SUBJECT: Forwards addendum to 831031 response to violations noted in  
 IE Insp Rept 50-397/83-38 re evaluation of concrete &  
 reinforcing steel, in response to 831108 telcon w/NRC.

Subject: NUCLEAR PROJECT NO. 2  
INSPECTION REPORT 83-38, NOTICE  
OF VIOLATION - CONCRETE

ADDENDUM TO RESPONSE TO INSPECTION REPORT 83-38  
NOTICE OF VIOLATION

EVALUATION OF CONCRETE AND REINFORCING STEEL  
FOR  
WASHINGTON PUBLIC POWER SUPPLY SYSTEM UNIT 2

W.O. No. 3900-03 Date 10/18/83 Book No. SV-102 Page No. 3 of 3  
 Drawing No. 6.19-137 Calc. No. 6.19-137 Sheet 3 of 3  
 By Hick Checked LF Approved LF  
 Title West - Head of 2 - Reactor Bldg - Ventilation - North Fuel Pool Wall  
Bethlehem Steel Rebar Placement Dwg - North Wall Fuel Pool

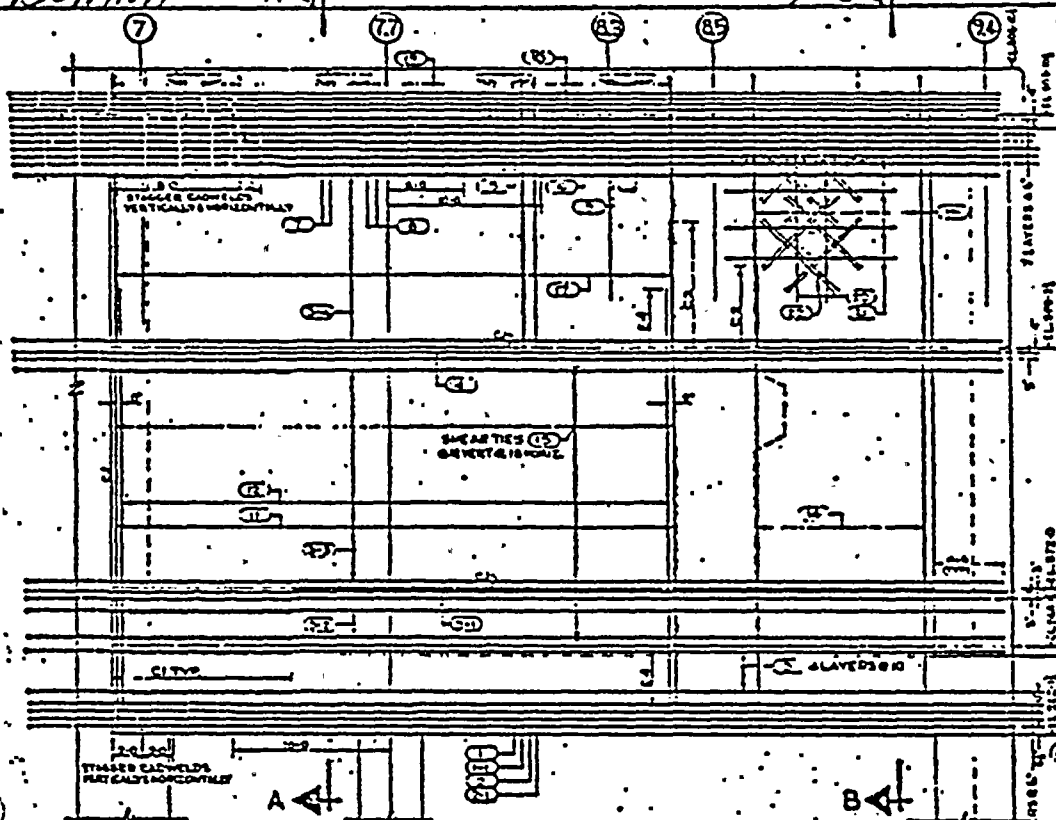
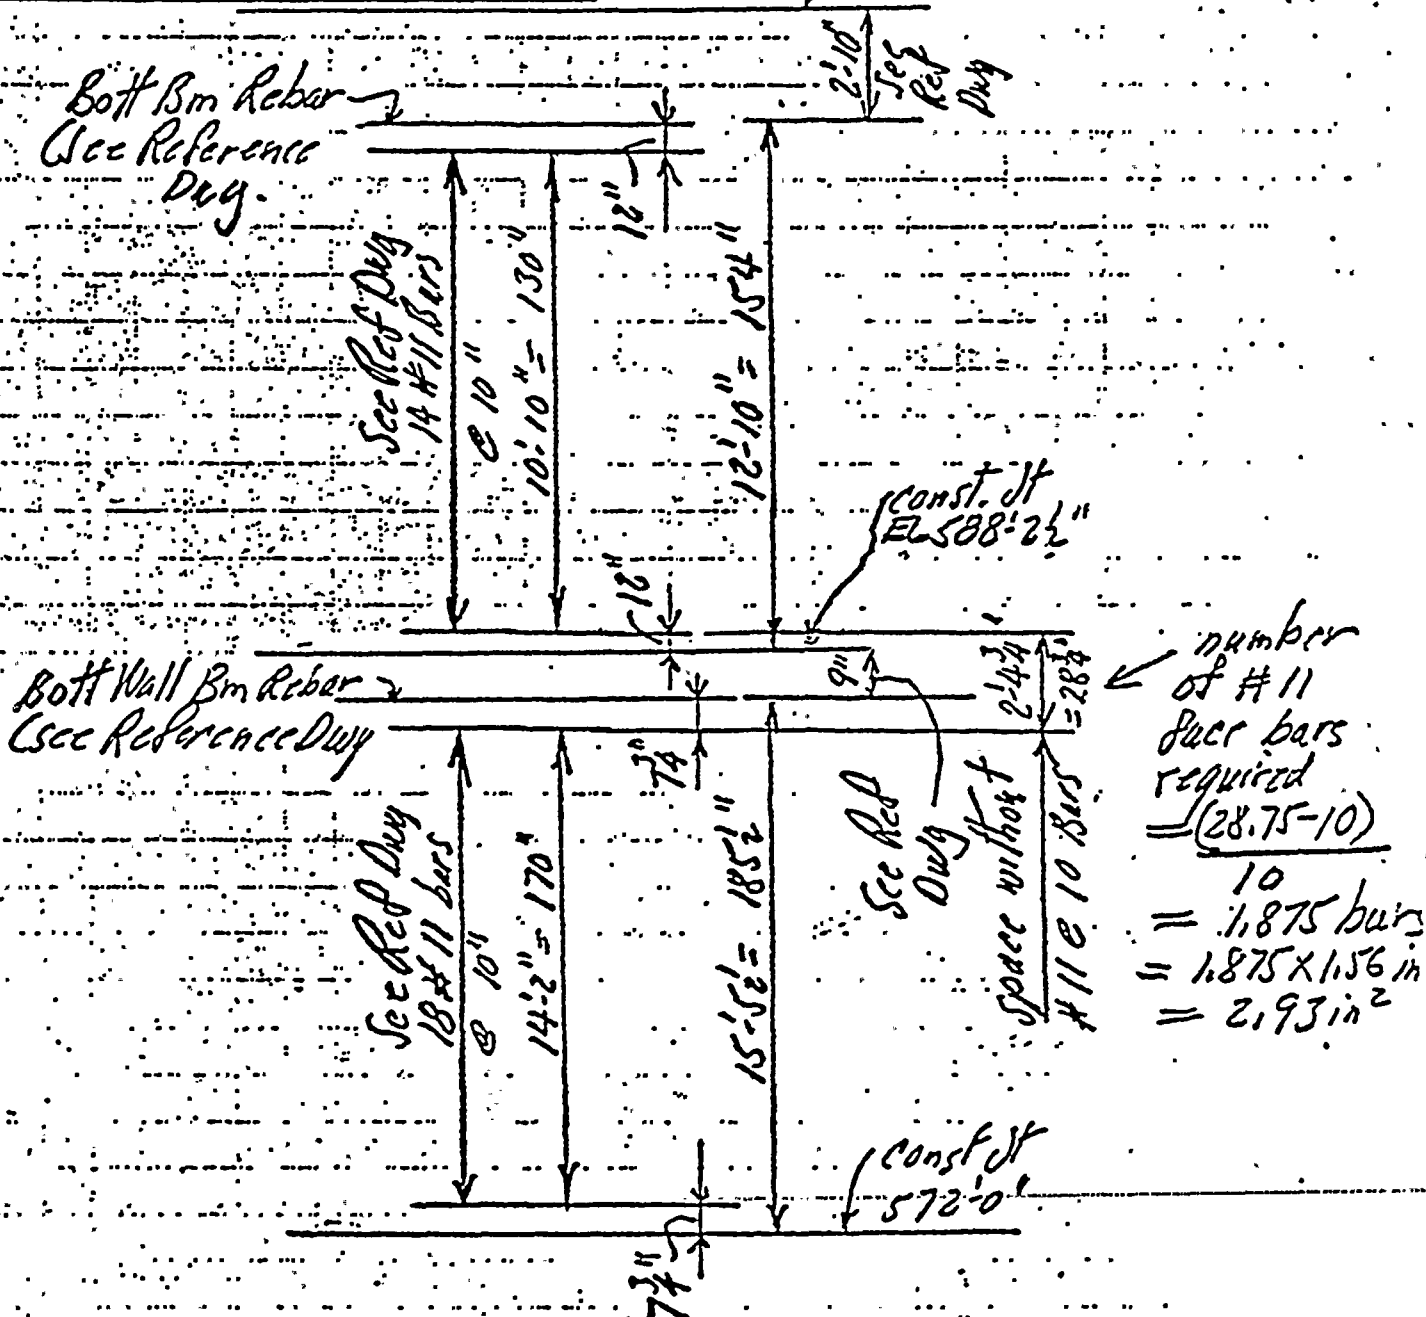
3. Provide calculation to substantiate disposition of spent fuel pool wall.

Burns & Roe Dwg S-723, Section 330 shows the horizontal Face reinforcing in the North Wall of the Reactor Bldg Fuel Pool Wall to be #11 @ 10" each Face, placed continuously from just above the constr. joint at elevation 568'-1 1/2" to the underside of the heavy horizontal wall beam reinforcing below elevation 603'-10 1/2". Bethlehem Steel Reinforcing placement drawing (Burns & Roe File No 6809-00-0095) for this wall, shows the same reinforcing, at the same spacing, between the same elevations, but with an interruption in the spacing in the vicinity of elevation of 588'-2 1/2" due to the presence of heavy horizontal Fuel Pool Wall Beam Reinforcing, placed primarily for Fuel Pool Wall Construction purposes.

It is the purpose of this calculation to show that the horizontal reinforcing in the wall in the vicinity of Elev 588'-2 1/2" is adequate in spite of the interruption in the spacing described above.

Response: This calculation was transmitted initially to Mr. Auluck during the week of October 24, 1983. A second copy is attached herewith.

This calculation shows that the wall beam reinforcing in the vicinity of elev 588'-2 1/2", placed there for construction purposes, has sufficient reserve strength to replace the #11 @ 10" called for on the Burns & Roe Drawing S723, Section 330, but interrupted by the presence of this wall beam reinforcing as shown on the Bethlehem Steel Reint placement drawing.

### North Fuel Pool Wall - Construction Sequence

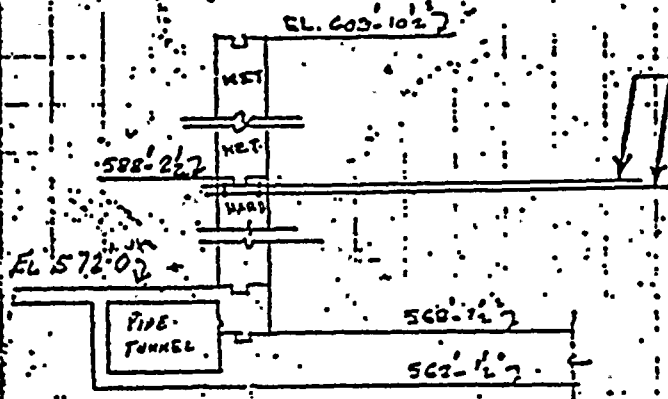
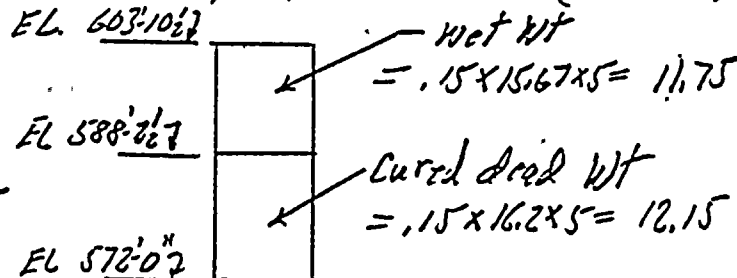
Investigation of Horizontal Wall face bars in North Fuel Pool Wall in vicinity of Elev 588'-2 1/2" where Face Bars are replaced by Horizontal Wall Beam Steel  
 Reference: Brittenham Steel Dwg; B&R File No 6809-00-0095 (Sheets 2&3)  
 Const. Jt. EL 603'-10 1/2"

From above, in the vicinity of Elev 588'-2 1/2" 2.93 in<sup>2</sup> of horizontal rebar is replaced by Horizontal Wall Beam Steel

The above section shows the location of the wall beam steel in the vicinity of elev. 588'-2 1/2", and its functional use in the supporting of the wet concrete pour above elev. 588'-2 1/2". After this wet concrete hardened and cured, this primary function was served. The design of this reinforcing is found on sheet 7, and it is shown that there is sufficient reserve strength in this reinforcing to satisfy horizontal face wall reinforcing requirements during operating conditions. (See Sh. 8)
